# Sustainable Traffic Solutions

RE: Responses to Comments on the Traffic Impact Study for the Haven School

## *Traffic Impact Study*

PCD File # AL2322

Haven School Traffic Impact Study  
**CONCEPTUAL IMPROVEMENT SKETCH FOR THE SITE ACCESS ON BURGESS ROAD**

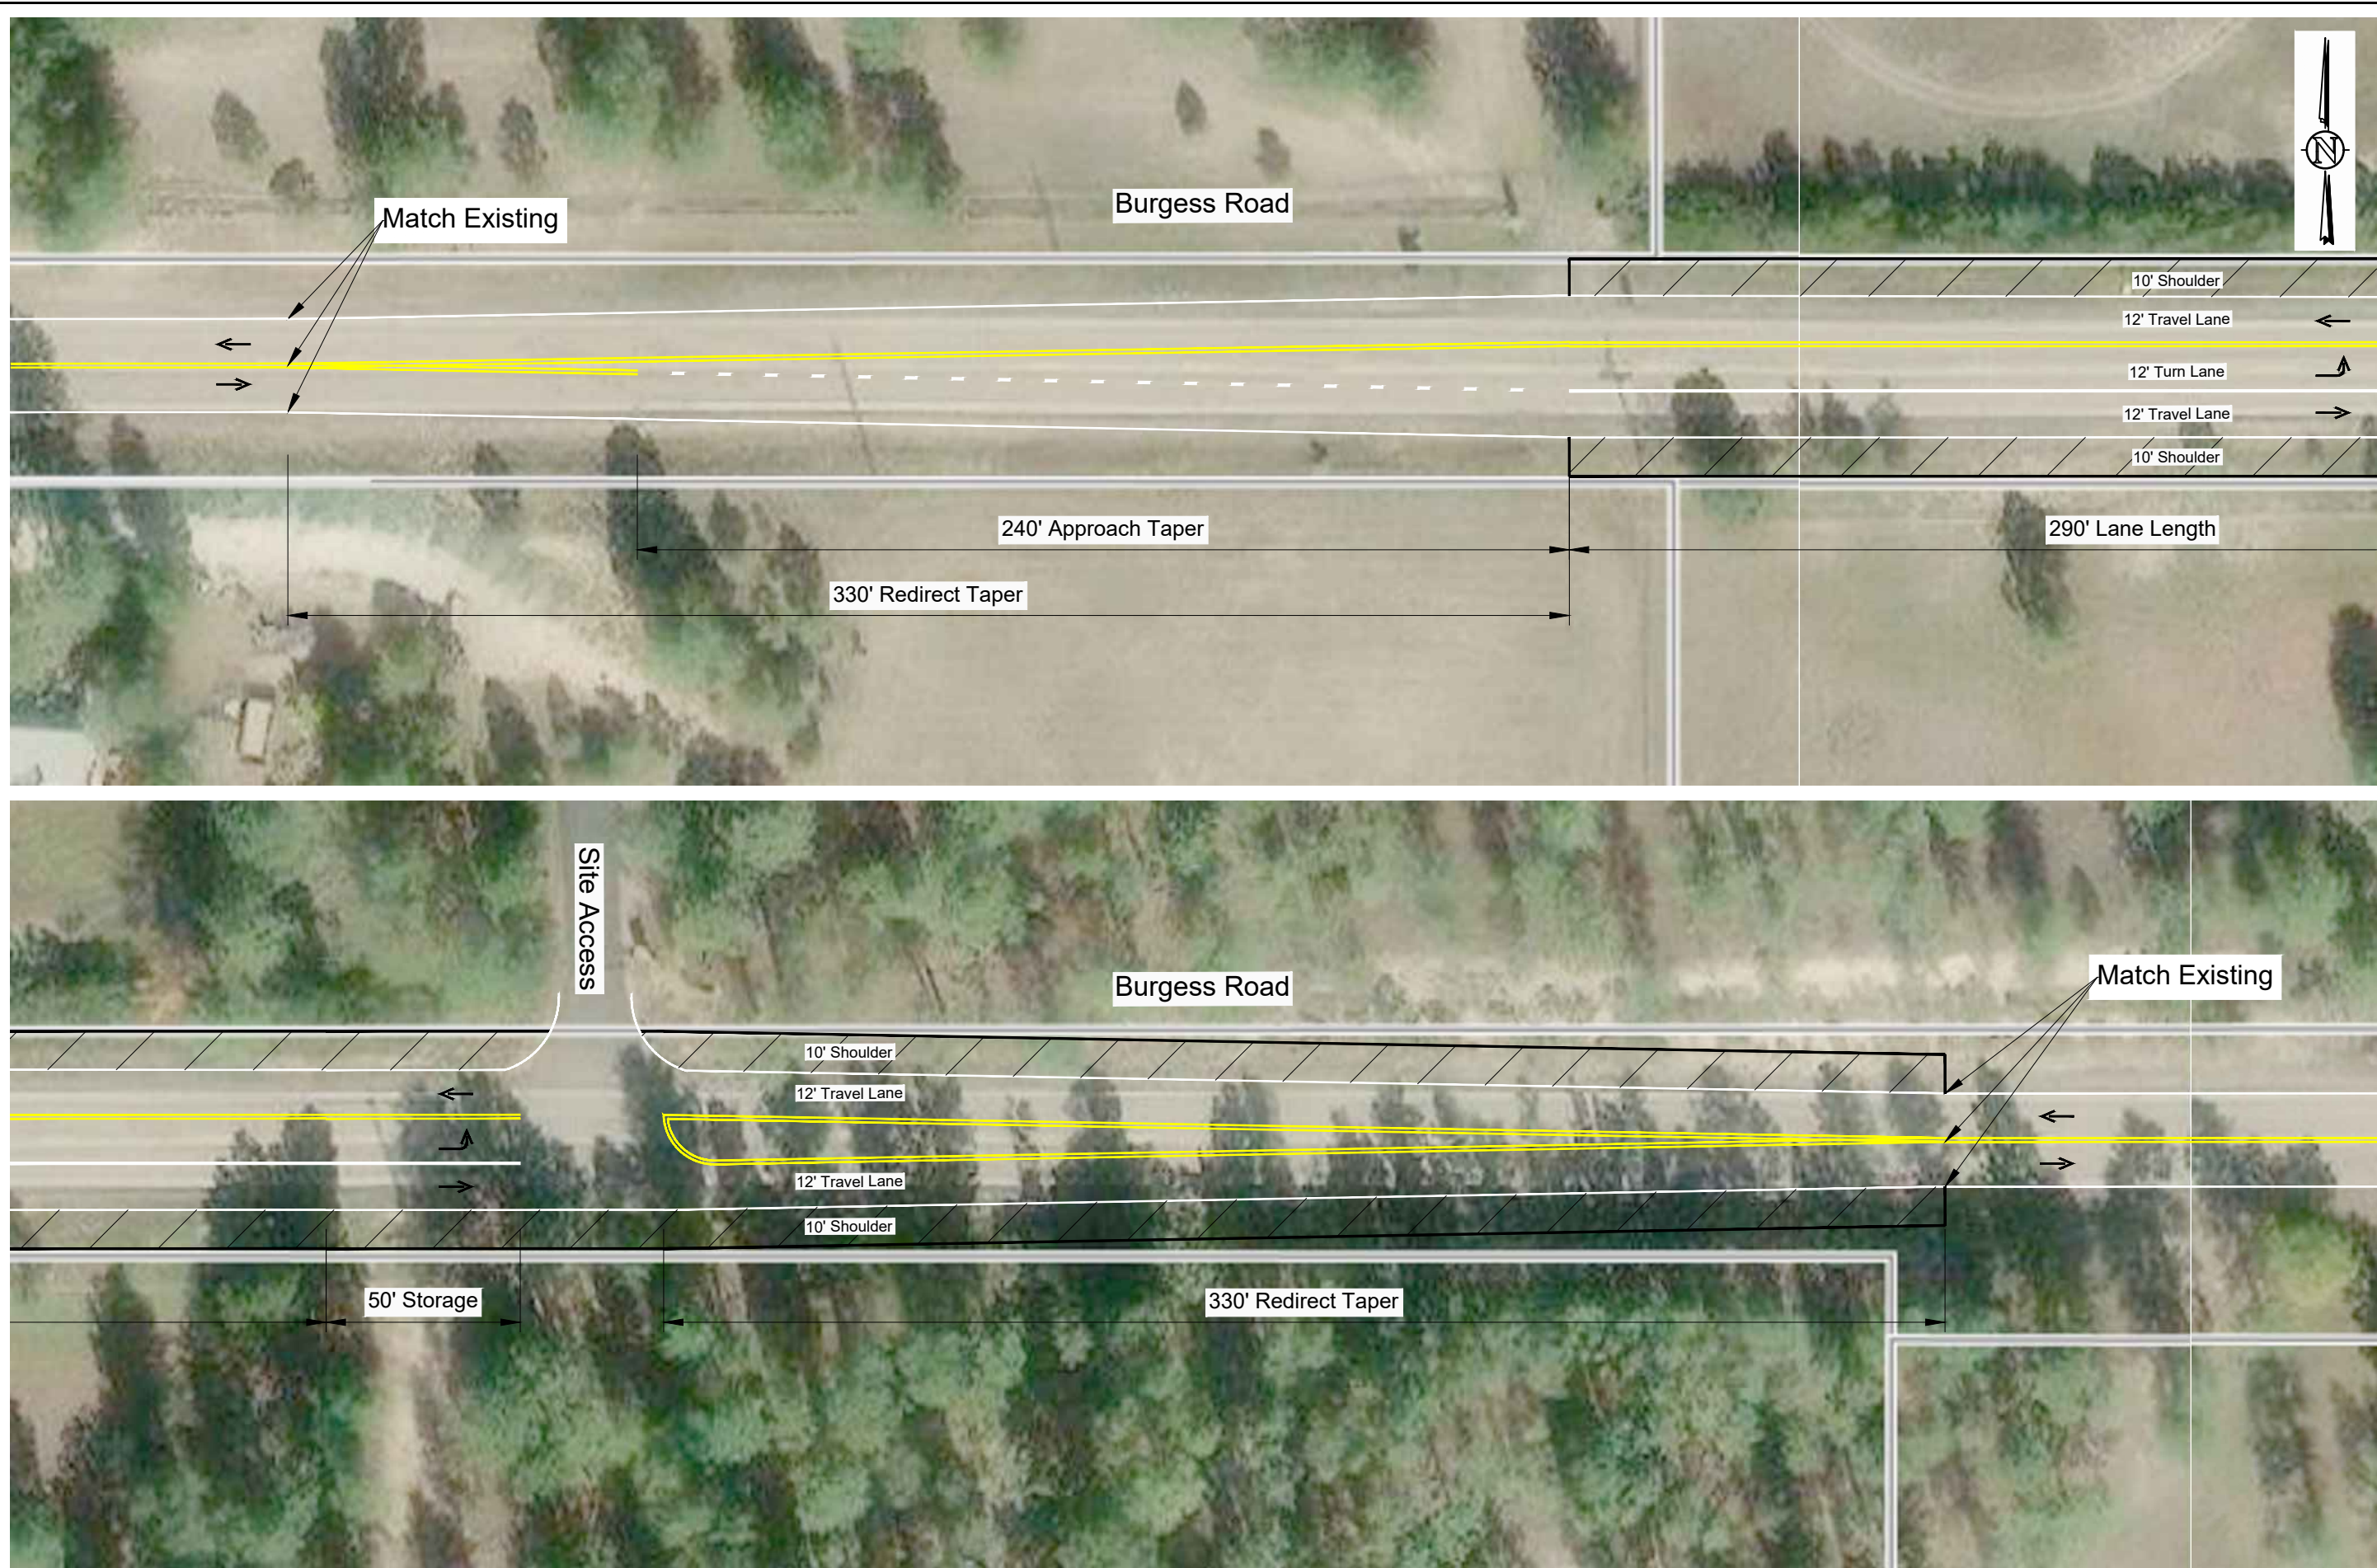
**Comment 12** Please state in the text whether or not a right turn decel lane or acceleration lane is required at the access. Additionally, please analyze and state whether any turn lanes are required or need to be modified at Burgess/Milam and Burgess/Black Forest due to this development's traffic impacts.

**Comment 22** From GIS aerials there is no existing aux. left turn lane at the access. Revise accordingly.

**Response** The correct figure has been inserted into the updated study.

Conceptual designs were prepared for both of the intersections to develop cost estimates. Figure 19 contains the conceptual design for the school access on Burgess Road and the conceptual design for Burgess Road / Milam Road is contained in Figures 20 and 21. The auxiliary lane lengths are included in Tables 4 and 5.

CONCEPTUAL IMPROVEMENT SKETCH FOR MILAM ROAD AT BURGESS ROAD

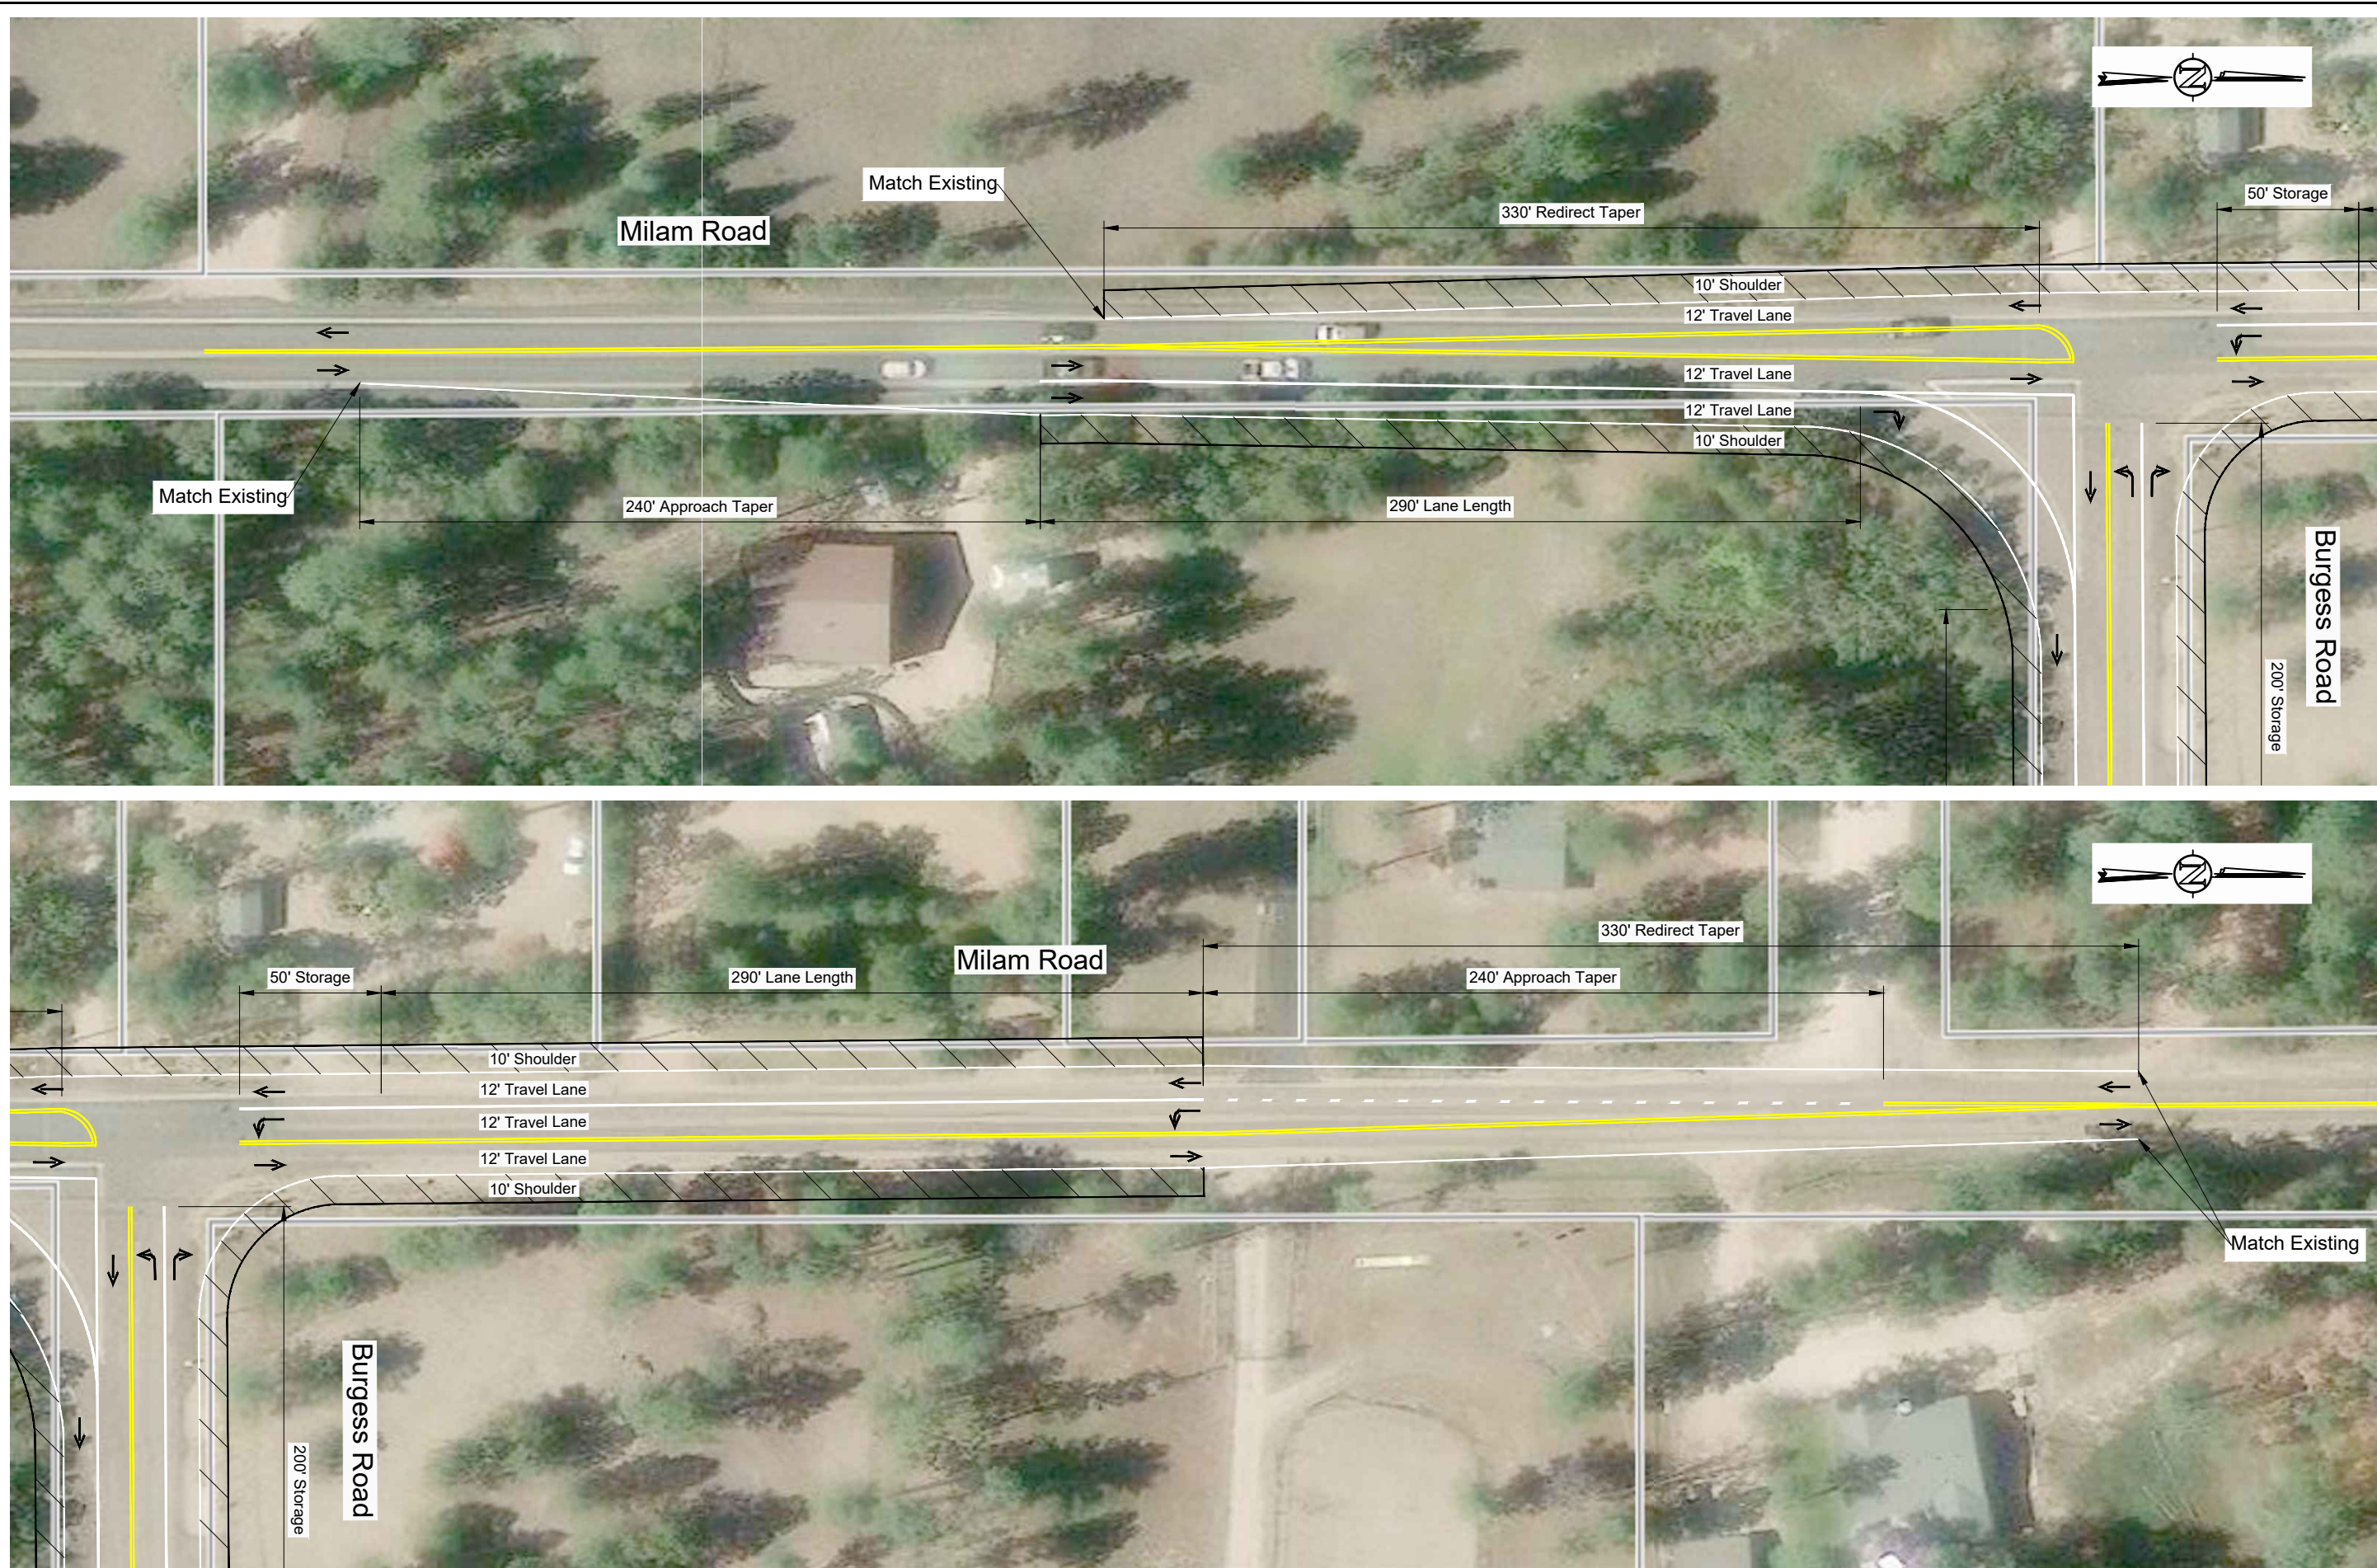
**Comment 24** The addition of a southbound Milam left turn to Burgess will need to be included for an escrow cost share based on the added traffic.

**Comment 25** The TIS will need to include the turn lane lengths, widths, and taper.

**Response** The estimated for the cost for the improvement is discussed in Section 9.1.

**Response** Refer to Tables 4 and 5.

Haven School Traffic Impact Study  
**CONCEPTUAL IMPROVEMENT SKETCH FOR BURGESS ROAD AT MILAM ROAD**

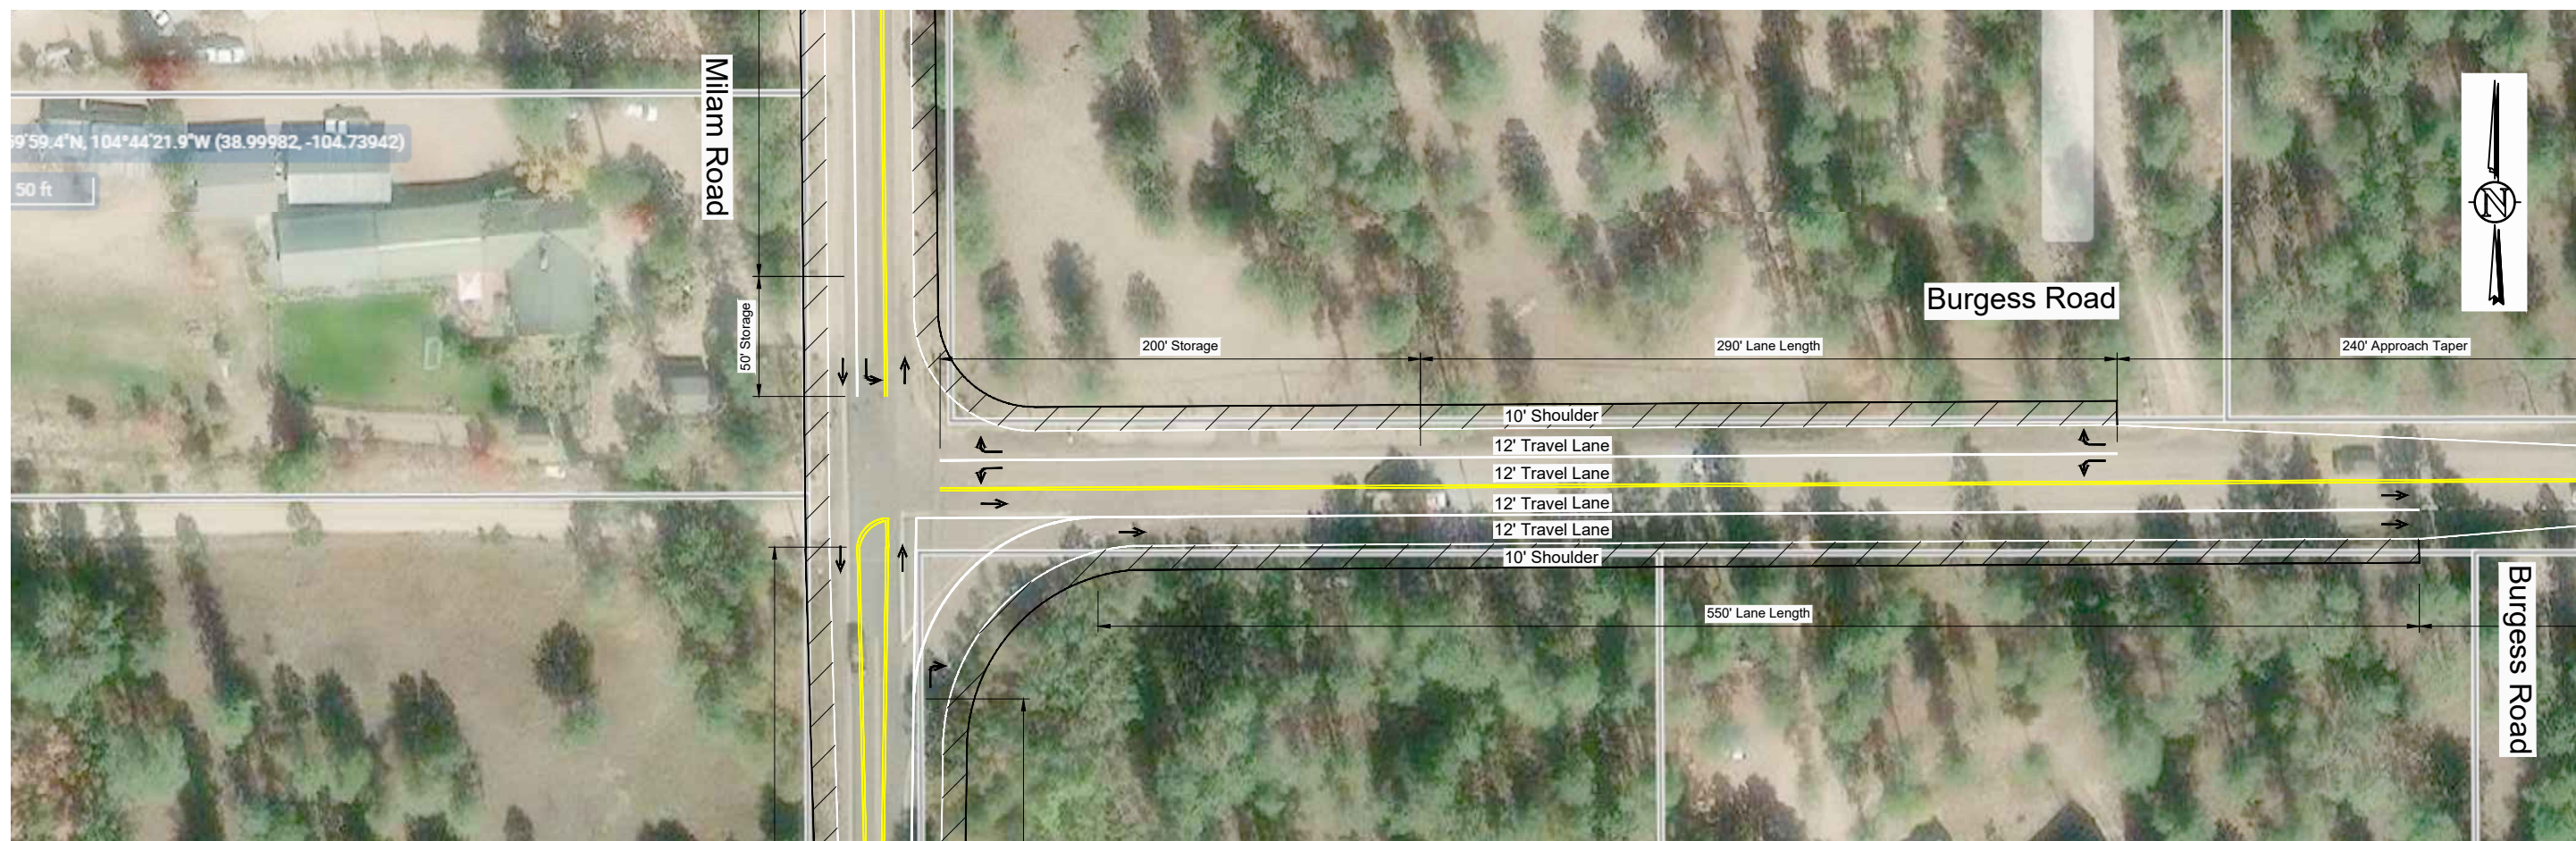
**Comment 27** The westbound Burgess at Milam will need to be included for escrow cost share for right and left turn lanes based on added traffic.

**Comment 28** The TIS will need to include the turn lane lengths, widths, and taper for these two turn lanes.

**Response** The estimated for the cost for the improvement is discussed in Section 9.1.

**Response** Refer to Tables 4 and 5.
